**DATE: SEPTEMBER 14, 2015**  
**TO: BLUE BIRD OWNERS**  
**SUBJECT: RECALL R15YA**  
**DRIVER'S HEATER SWITCH PANEL INVERTER FAILURE**

**NHTSA Recall Number: 15V181 School Bus**

## Driver's Heater Switch Panel Inverter Failure

Remove six (6) screws from Driver's Heater Control Panel

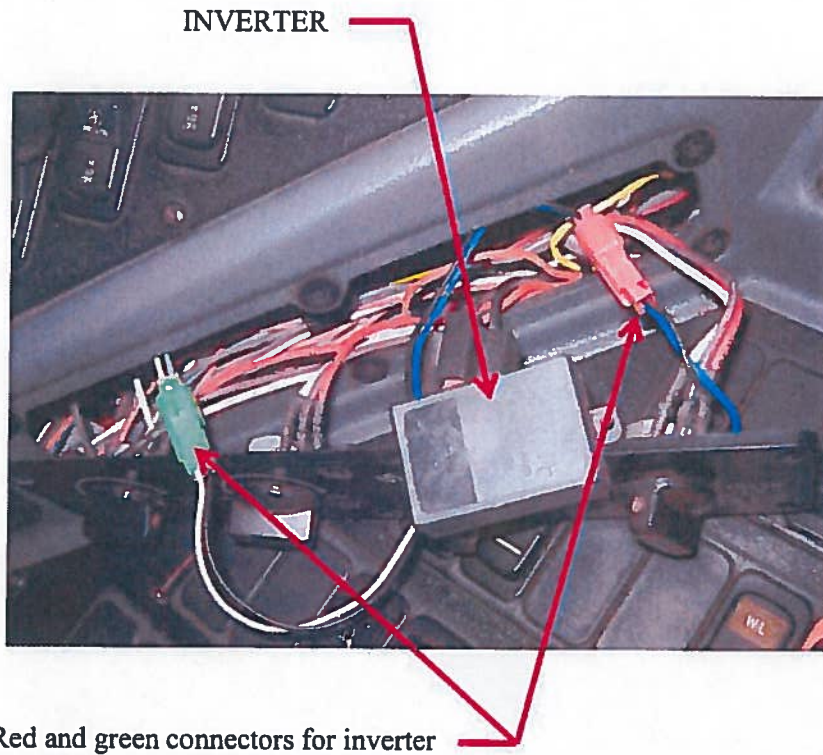
Inverters may have a manufacturing defect where the panel inverter may fail and may produce smoke and a possible thermal event.

Replace the inverter with a new inverter.

1. Park bus, apply parking brake, and remove ignition key.
2. Disconnect battery ground cable(s).
3. Driver's heater control panel is located on the driver's console.
4. Locate and remove six (6) screws that attach panel-to-console.

5. Pull the panel assembly toward the center of the bus to access inverter.
6. Unplug red and green connectors, and then remove inverter.
7. Connect new inverter to the appropriate red and green connectors. Place inverter and wiring back into the driver console and install the six screws that were removed in Step 4.
8. Reconnect battery ground cable(s).
9. Place bus back in service.
